AMENDMENTS TO THE DRAWINGS

REMARKS

ANNOTATED SHEET SHOWING CHANGES MADE

Figure 2

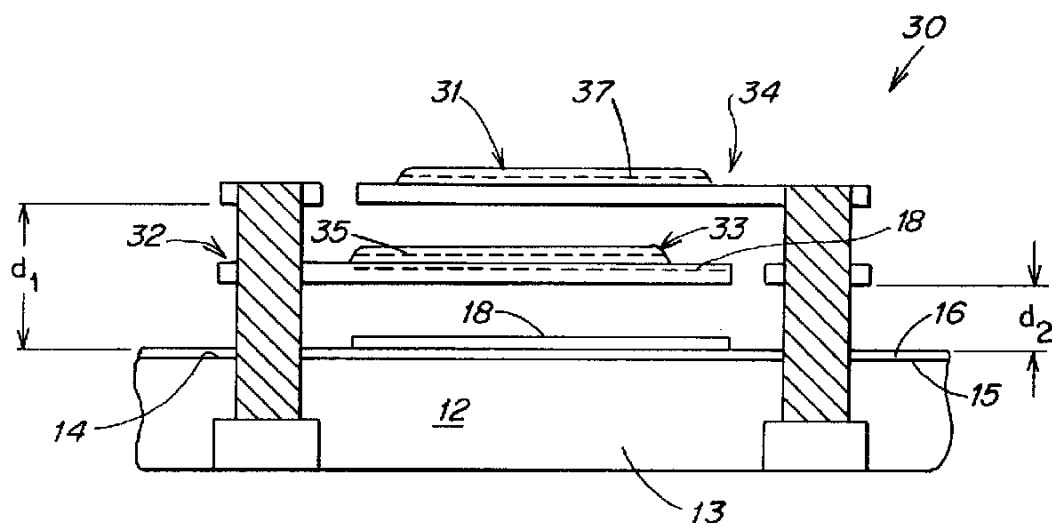
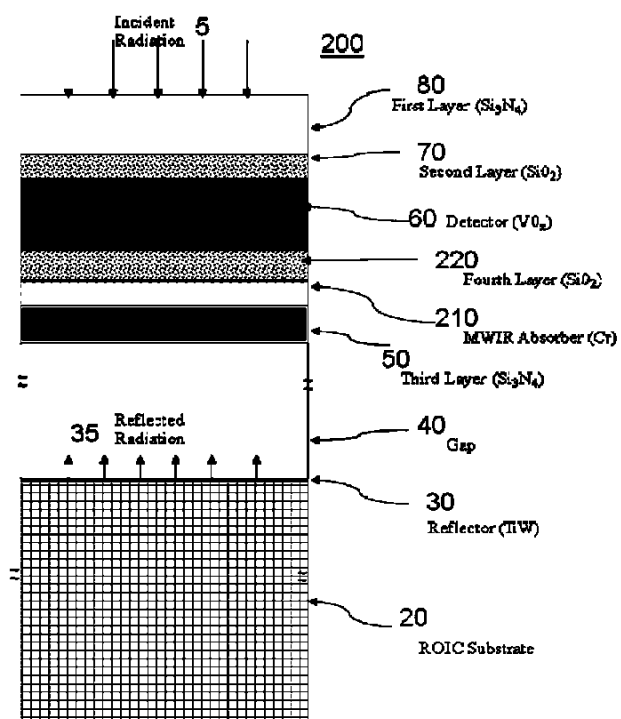
Figure 2 of Marshall et al .and Applicant's Figure 2 are included below to illustrate this distinction.

Marshall et al FIG. 2 showing a first microbridge level 32 and a second microbridge level 34.

Applicant FIG. 2 showing a single microbridge level with a single gap 40.

Marshall et al in describing the embodiment of Figure 2 specifies in column 5, lines 52-55 and subsequently that feature **32** is a first microbridge level and feature **34** is a second microbridge level. Applicant's embodiment of Figure 2 depicts a single microbridge level with a single gap **40**.

Independent claims 1, 6, and 13 have been amended to include "a single microbridge level" supported, at least, in Figures 2, 9, and 12 and paragraph 22 of the present application. Marshall et al use two independent microbridges to achieve dual band operation. The present application uses a single microbridge that is sensitive to dual bands. Sensing dual (or more) bands in a single microbridge is not the same as sensing dual bands in two independent microbridges. No new matter has been added.

Figure 3

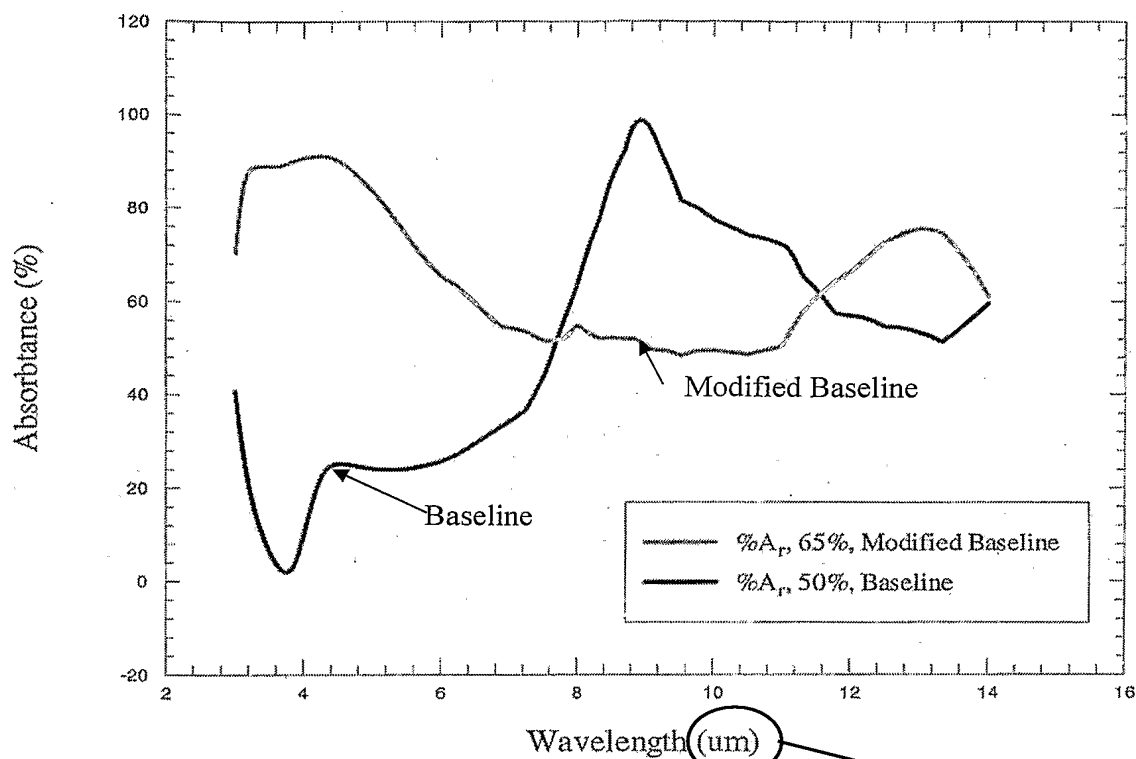
Changed to μm

Figure 4

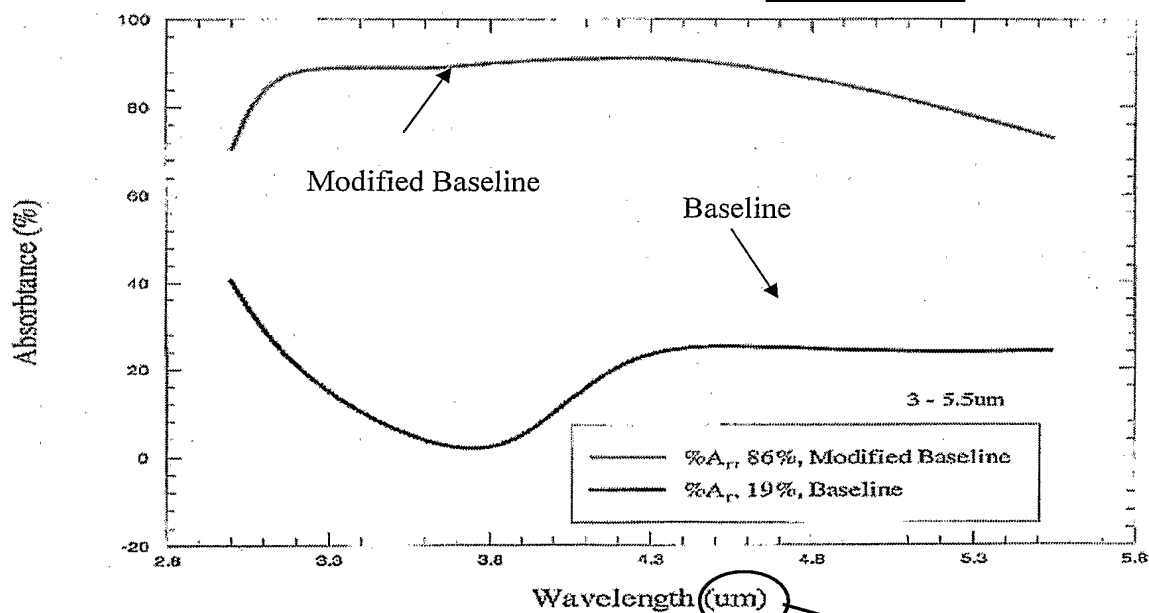
Changed to μm

Figure 5

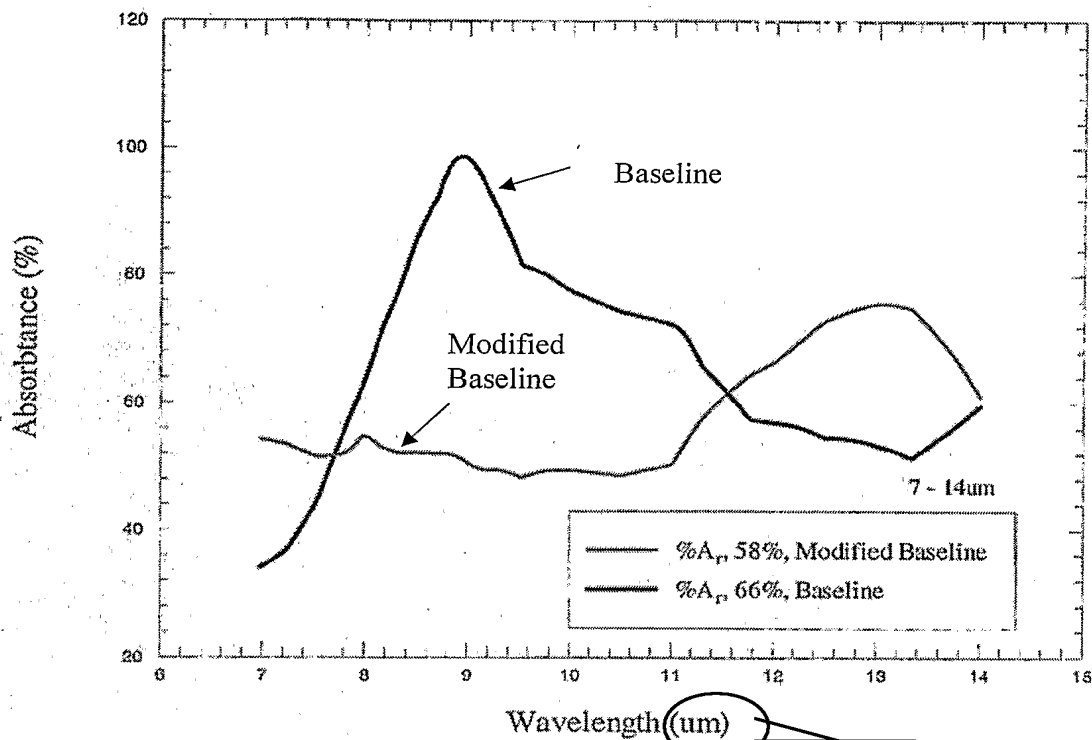
Changed to um

Figure 6

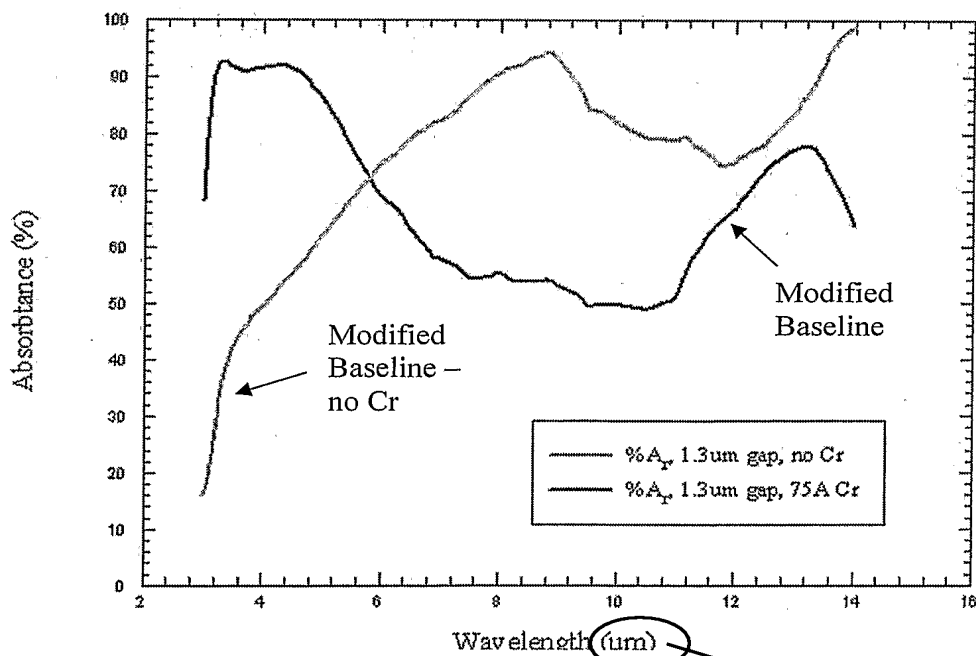
Changed to μm
